Work Order ID 88042

Item Name: Crosstube Mid Aft

DRAWING NO. REV. A  
D206-667-247 SHEET 1 OF 4  
TITLE SCALE  
CROSSTUBE ASS'Y (206L MID AFT) NTS

DRAWING NO. D206-667-247	TITLE CROSSTUBE ASS'Y (206L MID AFT)	REV. A	<b>DART AEROSPACE LTD ENGINEERING ORDER</b>		D.E.O. NO. D206-667-247-A-1	SHEET NO. SHEET 1 OF 1	SCALE NTS
DRAWN 92	CHECKED ASS	MFG. APPR. RD	APPROVED JMD		DE APPR. #		
DATE 11.07.15	DATE 11.07.20	DATE 11.07.21	DATE 11/07/21		DATE 11.07.21

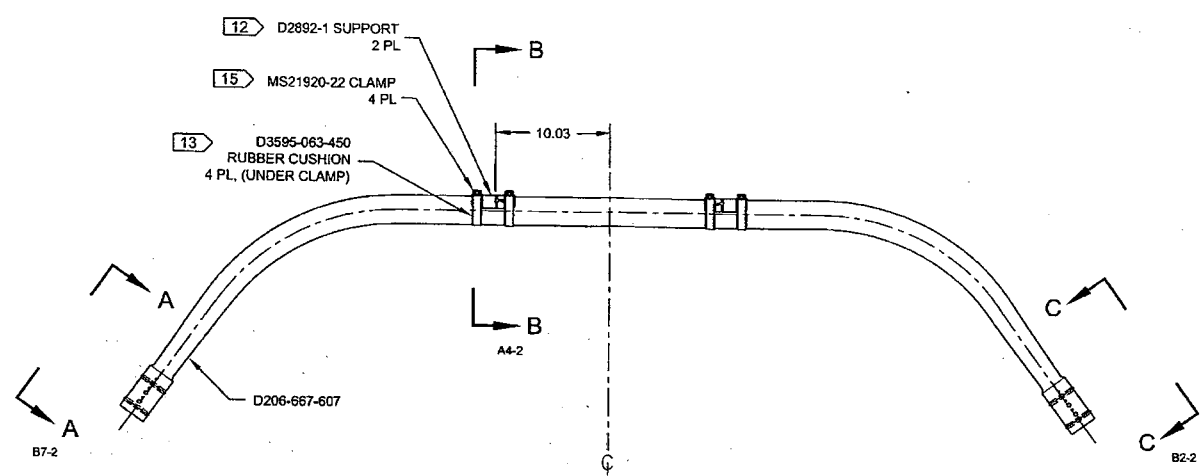
REPLACE MAGNOBOND WITH PROSEAL

NOTE 12 & 15, SHEET 1 IS AMENDED AS FOLLOWS:

12) TO INSTALL D2892-1 SUPPORT: ABRASE MATING SURFACE OF SUPPORT AND CROSSTUBE WITH 180-GRIT SANDPAPER AND REMOVE RESIDUE WITH MEK (OR EQUIVALENT). APPLY A 0.04" TO 0.07" THICK LAYER OF PROSEAL 890 CLASS B-2 (OR AMS-S-8802 CLASS B-2) SEALANT TO MATING SURFACE OF SUPPORT.
